ARCHITECTURAL SUPPLEMENTAL INSTRUCTIONS No. 1

Re: St Jude Catholic Church

Martsolf Architecture Project No. 2307

1. Sheets revised per City comments.

Drawing Title:	. SHEET
DEI7 (IE	. STILLI
Project No.	Date:
2023.297	1/12/2024
WILL A HERBERT	Sheet No.
92824 OCCENSED	\$4.2

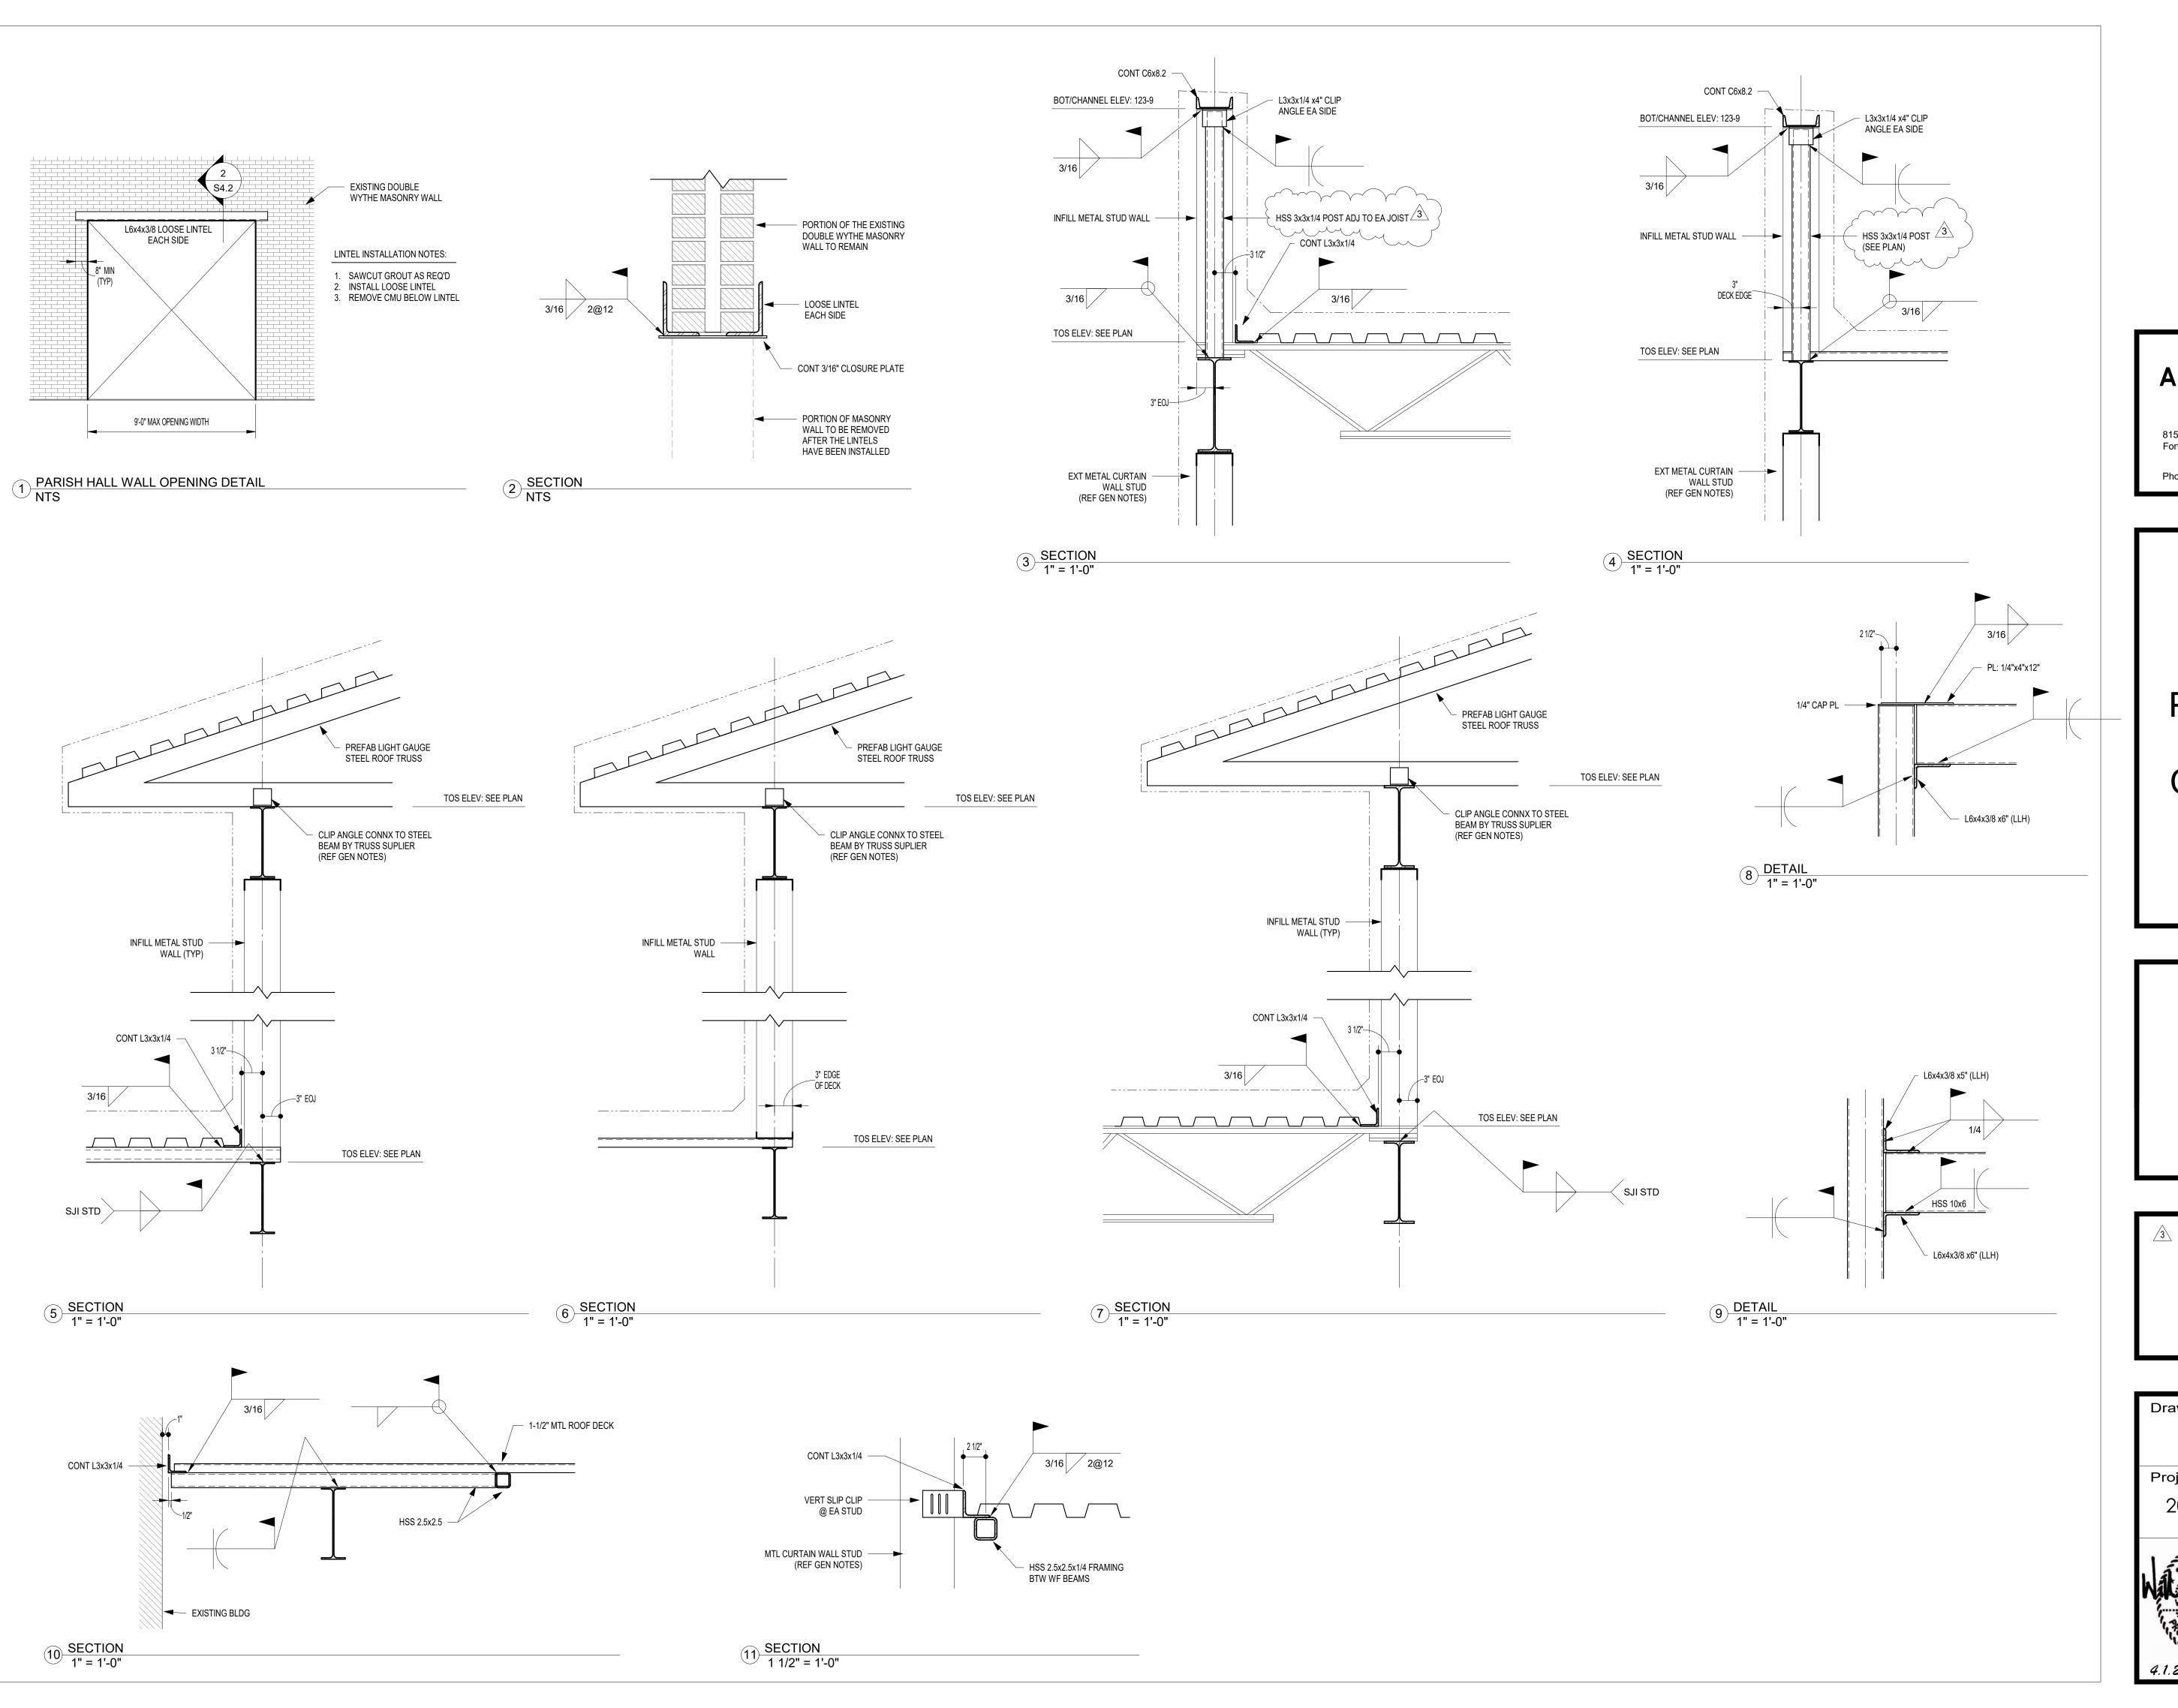
REVISION 3, CITY COMMENTS 4/01/2024
